## COALITION FOR THE WEST CREDIT RIVER

### INGROUND INFILTRATION OF WASTEWATER

The Coalition for the West Credit River (Coalition) is presenting a viable option to the current design of simply directing discharge of sewage effluent from the proposed Erin Wastewater Treatment Plant (Project) into the coldwater ecosystem of the West Credit River.

**Figure 1 - Approximately 200 m x 100 m Infiltration Zone (option 1 and option 2)**

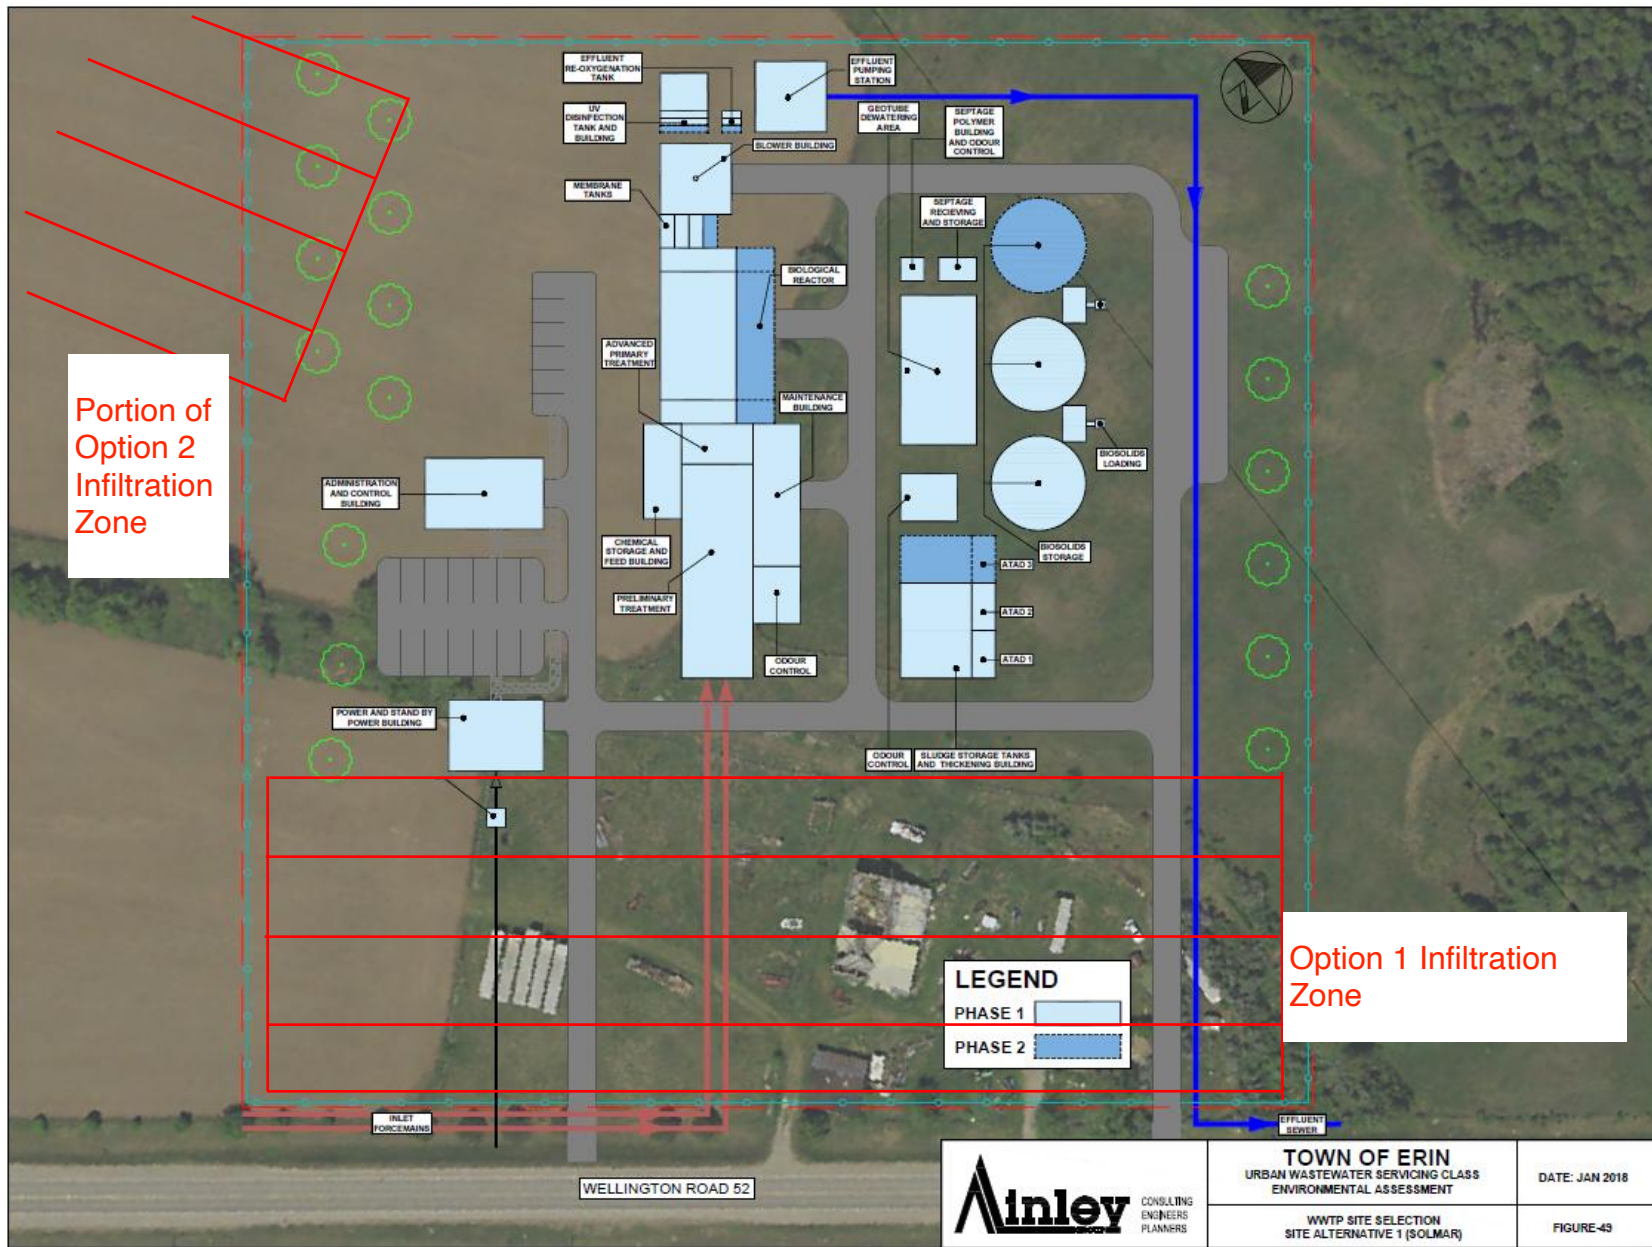
- Figure 1 – Ainley drawing showing the general layout of the treatment plant on a 5 Ha parcel on the overall 39 Ha Solmar Site.
- Figure 2 – Overall drawing of the 39 Ha Solmar site on the northeast side of County Road 52, which also shows the 5 Ha Project site parcel.
- Figure 3 showing the overall area around the 39 Ha Project site including lands on the south side of County Road 52.

In all figures we show the schematic locations of a 200 m by 100 m infiltration zone (2 Ha) that could be used to discharge the treated effluent into the groundwater.

The Option 1 location is immediately northeast of County Rd 52 on the 5 Ha Project site parcel. Option 1 takes advantage of the 200 m long by 100 m wide area that appears to be reserved as setback lands from County Rd 52 and provides no other function at the site. This land is therefore available for a large 2 Ha infiltration bed.

Option 2 is a similar sized infiltration bed located just west of the 5 Ha Project site that would also be suitable for inground disposal of the effluent.

**Figure 3 - Erin WWTP Site Relative to County Road 52 and the 10th Line**

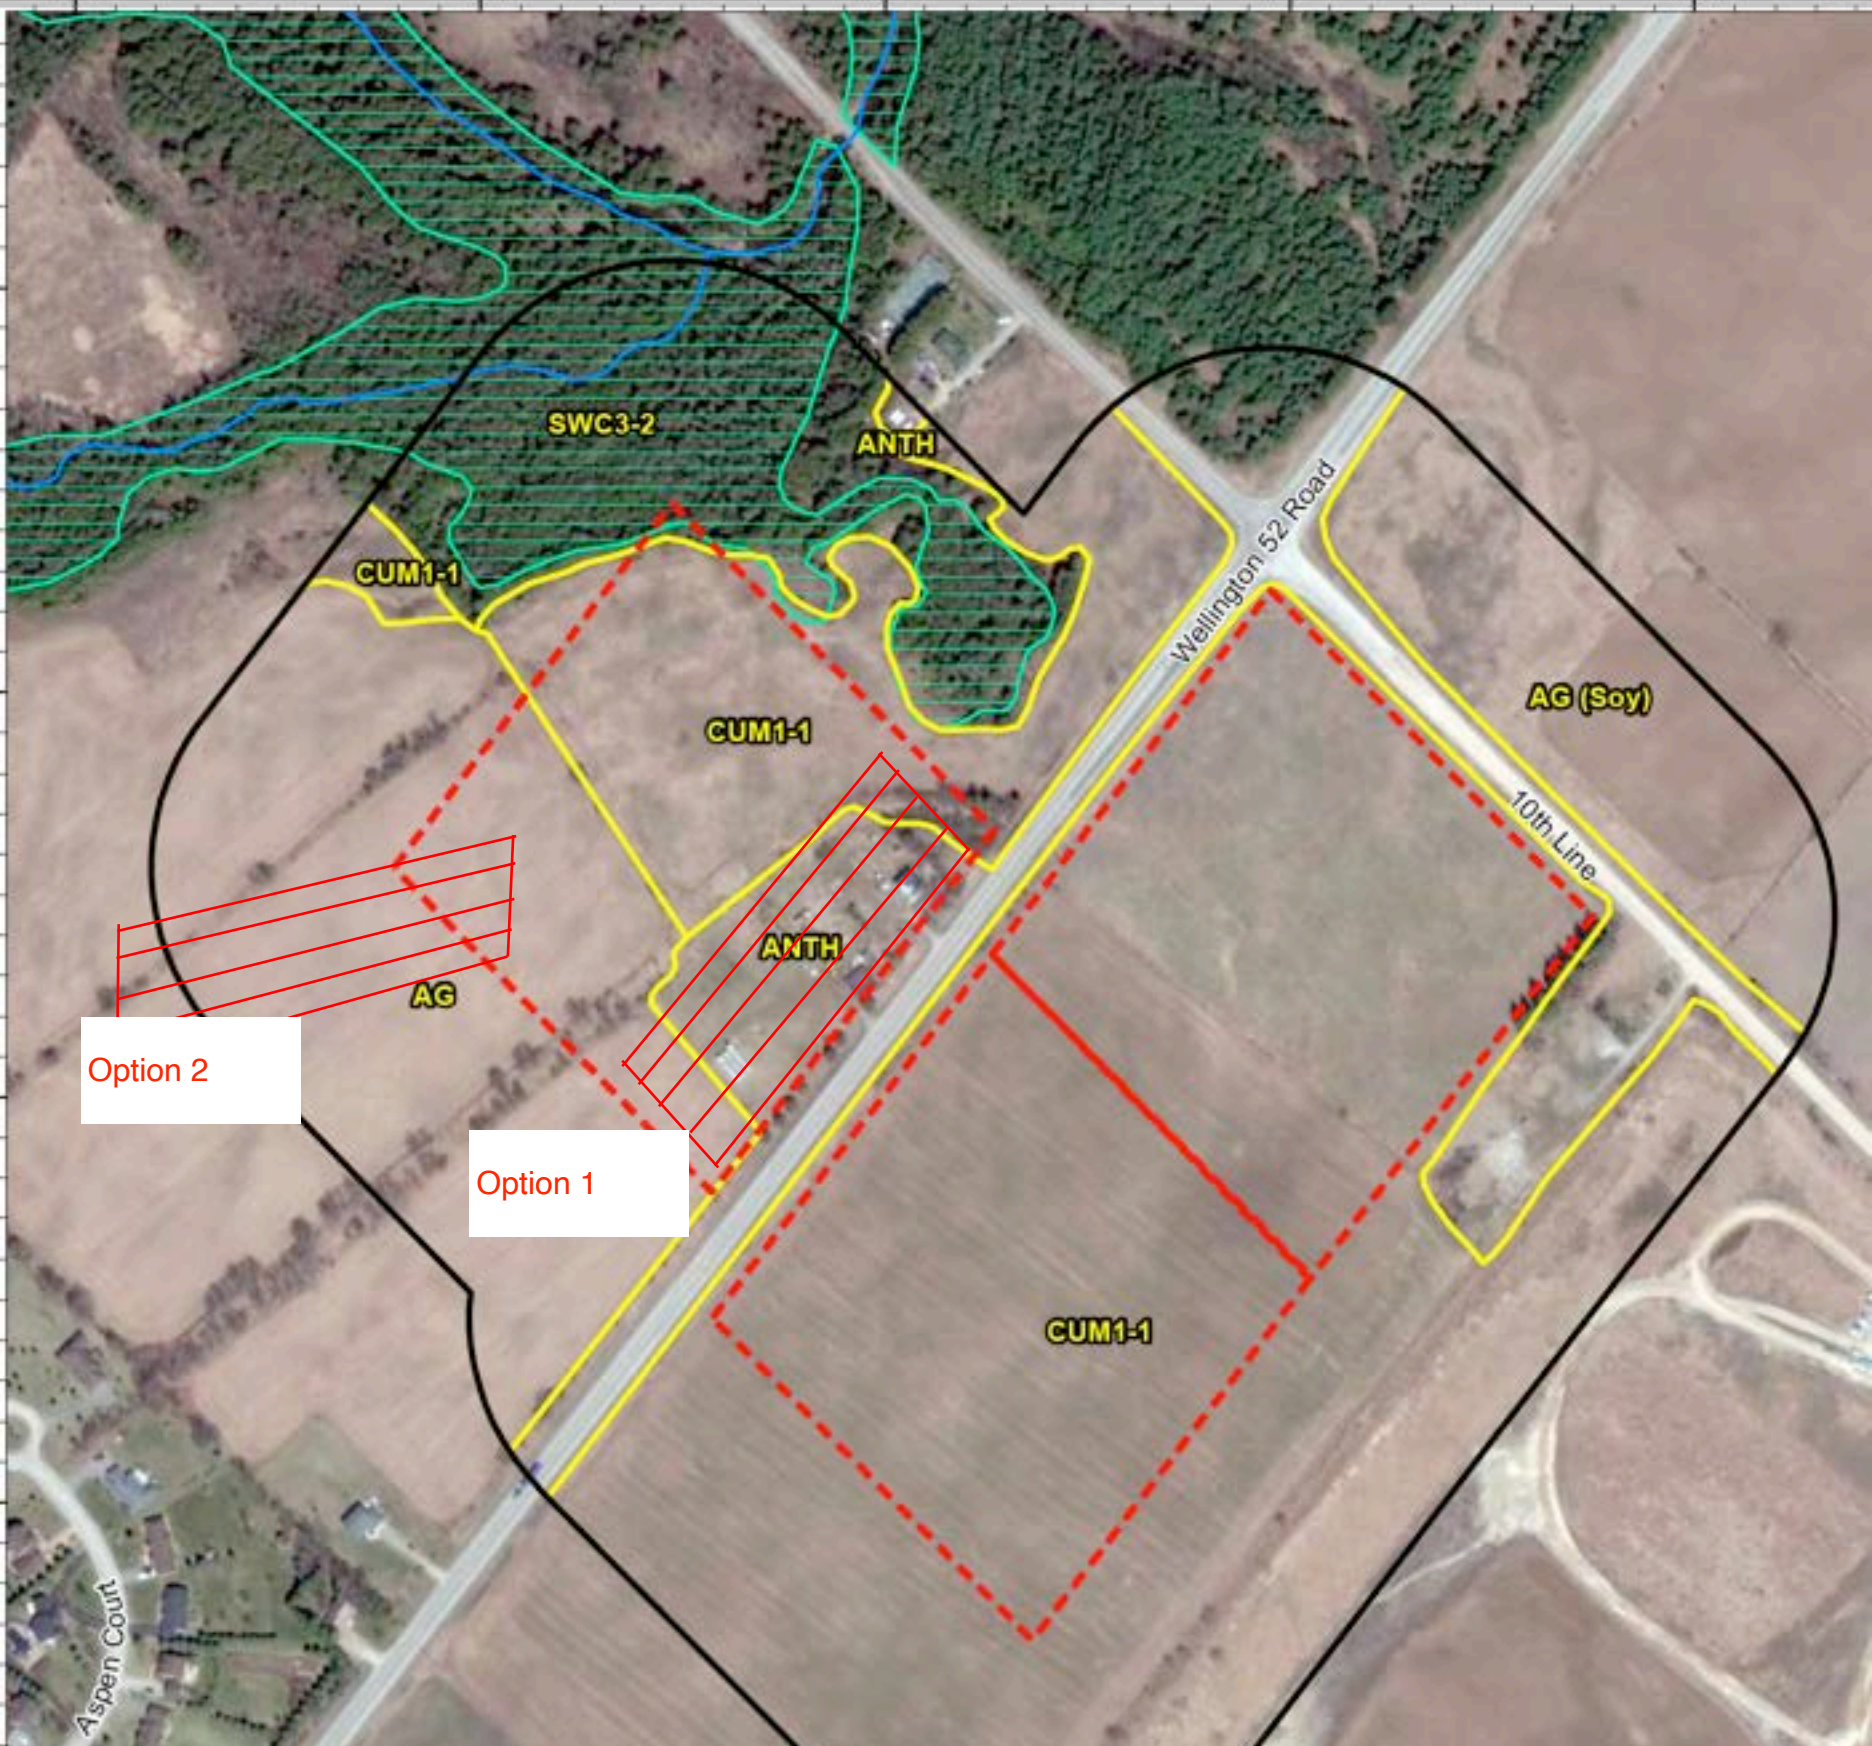
While 4 Ha exceeds the 2 Ha parcels shown in Figures 1, 2 and 3, it simply means that both infiltration areas should be used, or that the effective area for infiltration will spread out to say the 4 Ha below each 2 Ha area. Or the higher application rate of 40 cm per day (point vii) could be justified.
